Submission on Proposed Plan Change 7 – Rotokauri North Private Plan Change

Proposed Plan Change 7 Submission

Figure 15 -7a

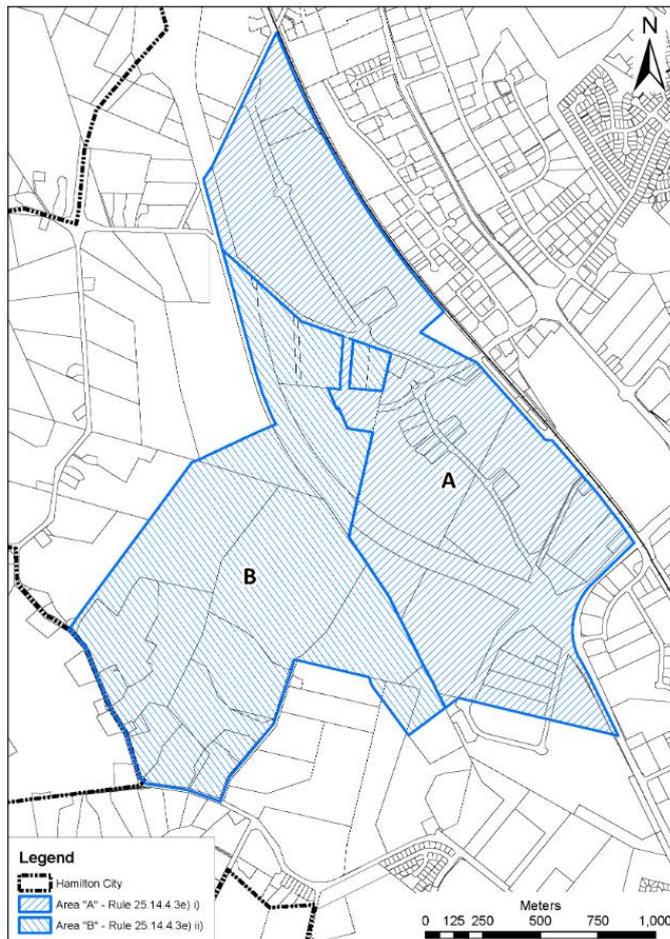
The proposed plan change is inconsistent with structure plan component *“3.6.3.2 Roothing”* in its entirety. The proposed area is within the stage 2 area, outside of Areas A and B (see Figure 15-7a). The Rotokauri Structure Plan indicates that the release of land beyond stage 1A (such as the PPC): *“will be contingent upon the availability of network capacity which may arise as a result of traffic generation”* and 3.6.2.3 d and e) provide that:

Proposals for the development of land in ‘Area B’ on Figure 15-7a will require careful scrutiny to ensure that adequate network capacity exists to support the development, or will be provided as part of the development and they will not compromise the development of land in ‘Area A’ on Figure 15-7a. Development will require:

e) The development of land outside Areas 'A' and 'B' (Figure 15-7a) will need to coincide with the northwards extension of Rotokauri Minor Arterial Road to connect with Te Kowhai Road at the City Boundary.

The PPC is clearly contrary to these provisions, and the developer is trying to dodge the full cost of developing ahead of the planned sequencing by exempting itself from these Rotokauri Structure Plan provisions. The PPC does not provide adequate transport network capacity outside of the PPC area to support the proposed development. The proposal does not achieve a sustainable expansion of the city and does not represent coherent and integrated development, because the transportation effects beyond the Rotokauri North boundaries have not been resolved.

- Either decline the private plan change; or
- Decline proposed inclusion of section 3.6 d (exemption of PPC area from Rotokauri Structure Plan), but approve the development subject to requiring the developer to adhere to all existing Rotokauri structure Plan provisions, including:
 - a) requiring they construct the Rotokauri Minor Arterial Road;
 - b) provide an ITA that adequately assesses impacts on the wider transport network and have that ITA peer reviewed.
 - c) cater for the demand generated within the wider transport network;

- d) requiring the developer to fund all necessary road network upgrades and additions.
- e) provide a full economic assessment of the financial impact on the remainder of the Rotokauri Structure plan area and including the likely cost of the required roading upgrades.
